CAPE COD COMMISSION

PROJECT #: TR99025

PROJECT: Subaru of New England
124 Waterhouse Rd.
Bourne, MA

DECISION OF THE CAPE COD COMMISSION

SITE PLAN FOR
SUBARU OF NEW ENGLAND

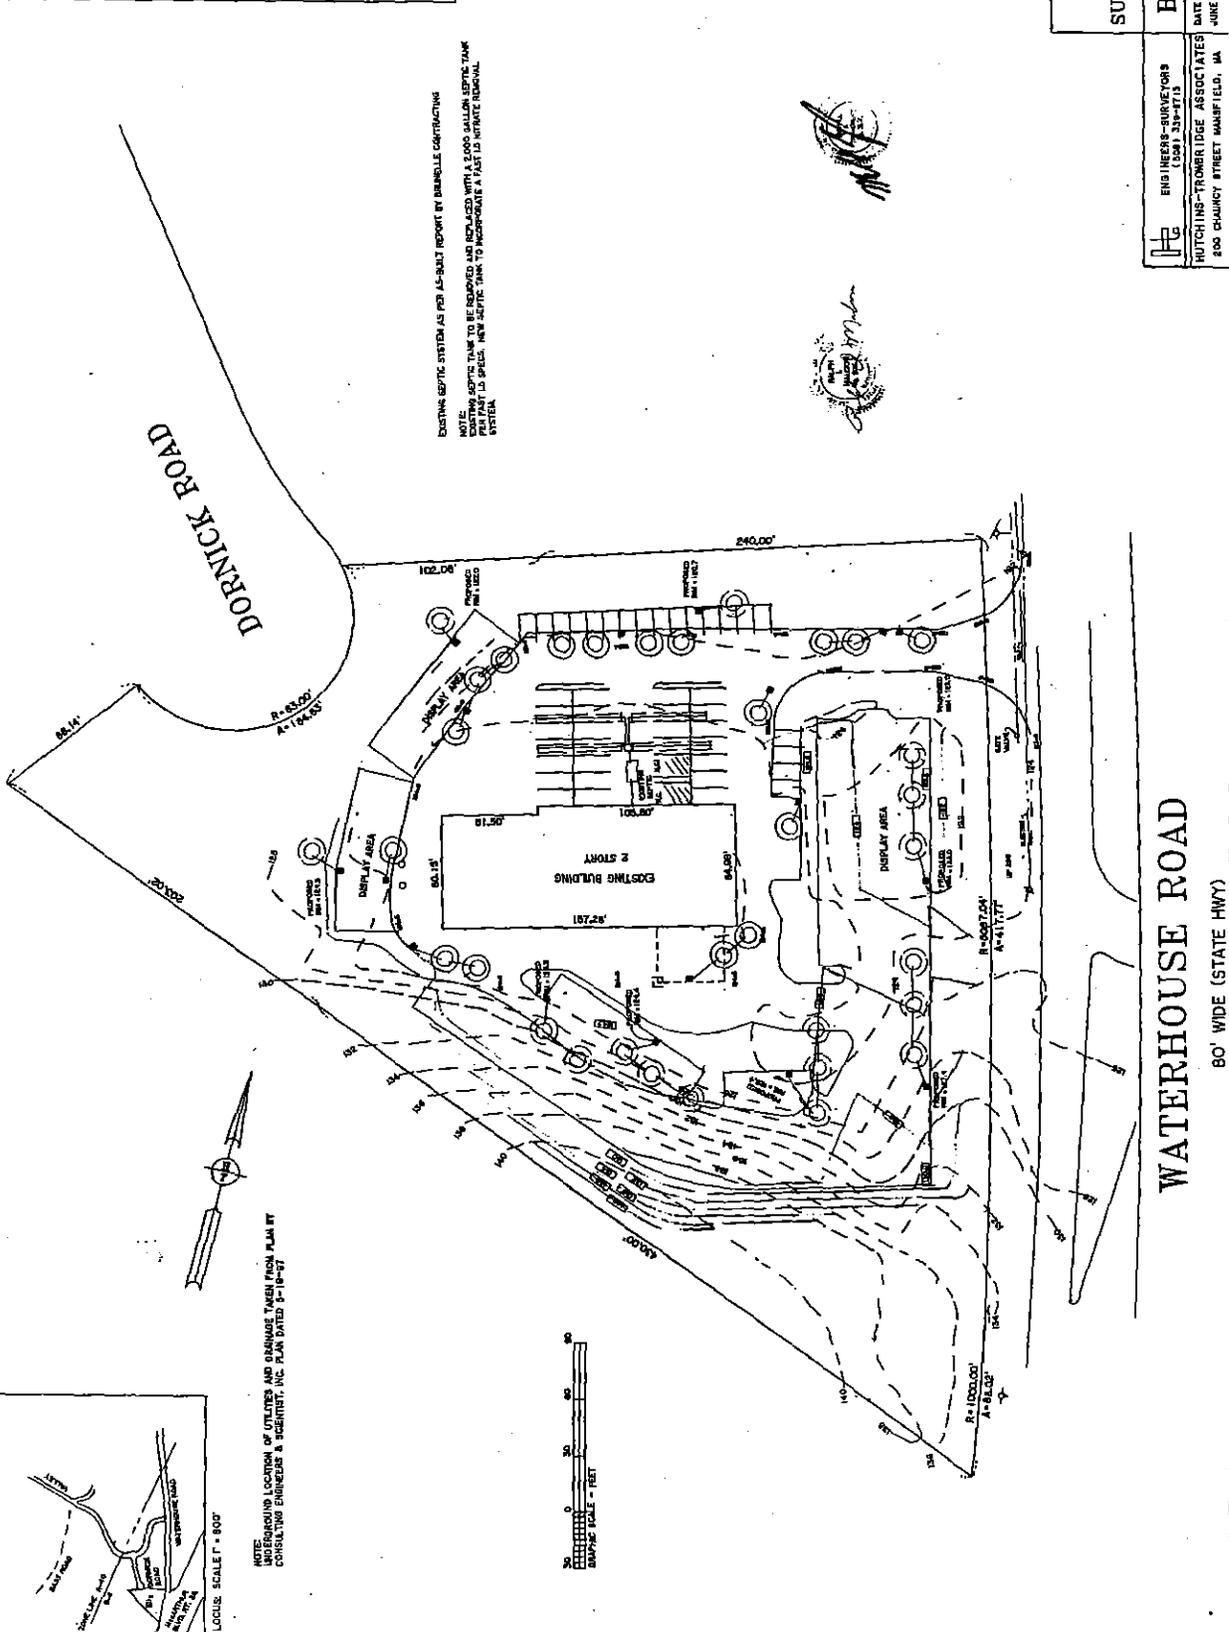
CC9. A site plan dated 6/2/99 was submitted as part of the DRI application which showed estimated maintained footcandle (fc) levels of light fixtures at levels ranging from .86 fc to in excess of 40 fcs. These levels are well in excess of Technical Bulletin Standard 2.8 which sets 8.0 footcandles as a maximum initial level. The plan also showed mounting heights of 15-25 feet which is not in conformance with Technical Bulletin Standard 2.6, as Waterhouse Road is a regional road.

CC10. The applicant then submitted a revised lighting plan dated 11/22/99 which shows a change to the heads of existing fixtures from 30-inch, 400-1000 watt metal halide bulbs to 14-inch, 100-175 metal halide bulbs, resulting in a reduction of light output. The revised plan also showed the removal of several pole lights noted as "existing" on the original 6/2/99 lighting plan. The revised site lighting plan also indicates pole-mounted lights are in conformance with the Commission's Technical Bulletin Standards 2.3, 2.4, 2.5 and 2.6. The 11/22/99 lighting plan shows footcandle levels ranging from 1.0 fc to 7.50 fcs, which are consistent with the Technical Bulletin.

CC11. Manufacturers catalog information provided in the DRI application for wallpack lighting notes that the lights selected come equipped to provide a 94-degree cutoff. Standard 2.7 of the Technical Bulletin sets a 70-degree cutoff for wallpacks.

CC5. Prior to issuance of a Certificate of Compliance, in-the-field verification of light levels shall be conducted by Commission staff to verify conformance with the requirements of the Technical Bulletin 95-001 and MPS 6.2.7. This review shall be based on the revised exterior lighting design plan dated 11/22/99. Prior to issuance of a final Certificate of Compliance, the applicant shall also submit information which shows wall packs conform to the requirements of Technical Bulletin standard 2.7.

SITE PLAN
 FOR
SUBARU OF NEW ENGLAND

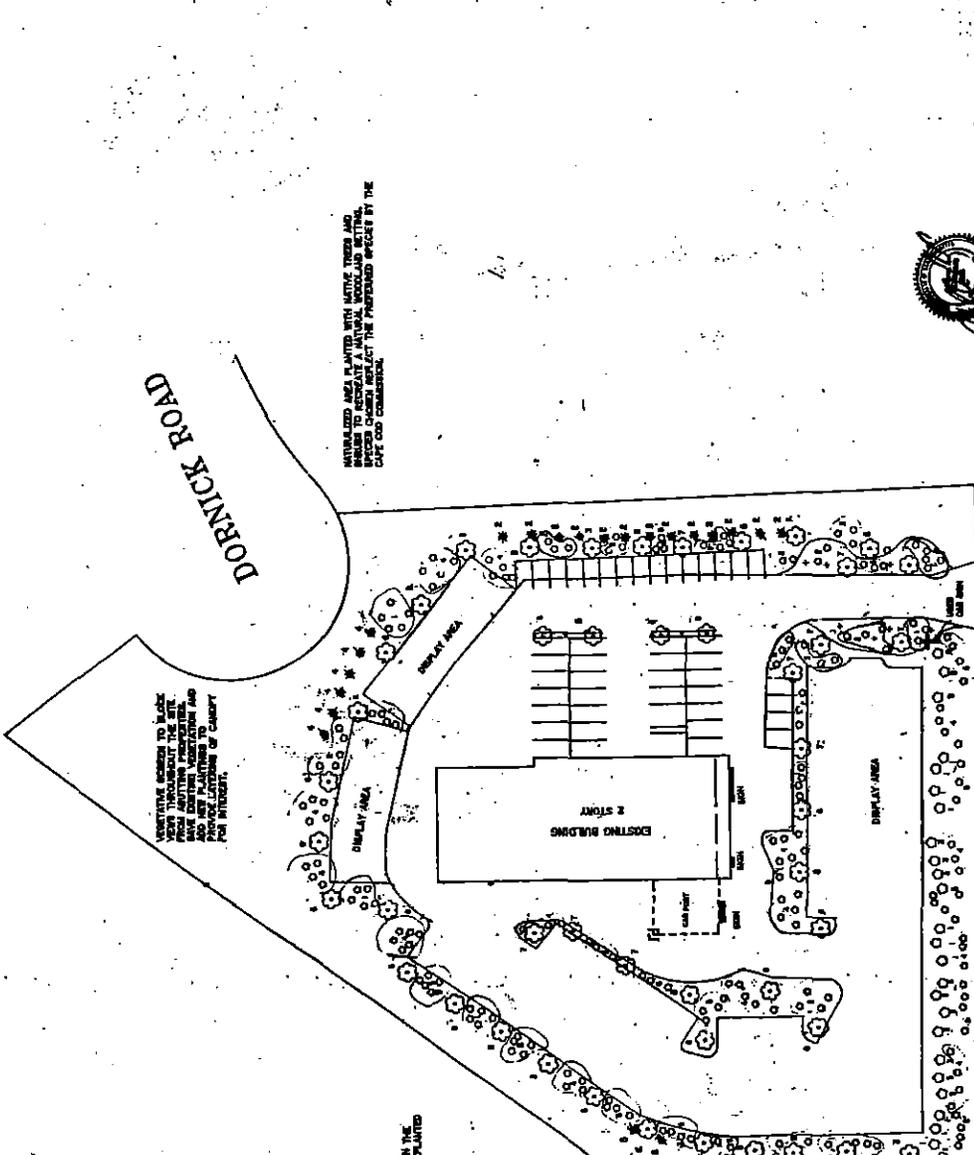
CC5. MPS 6.2.3 requires that all new development provide adequate landscaped buffers to limit adverse visual impacts to the surrounding area. The applicant agreed to provide additional landscaping to improve existing buffers to the site from surrounding roadways.

CC2. Prior to issuance of a Certificate of Compliance, all landscaping shall be completed in accordance with the final landscaping plans dated 3/17/00.
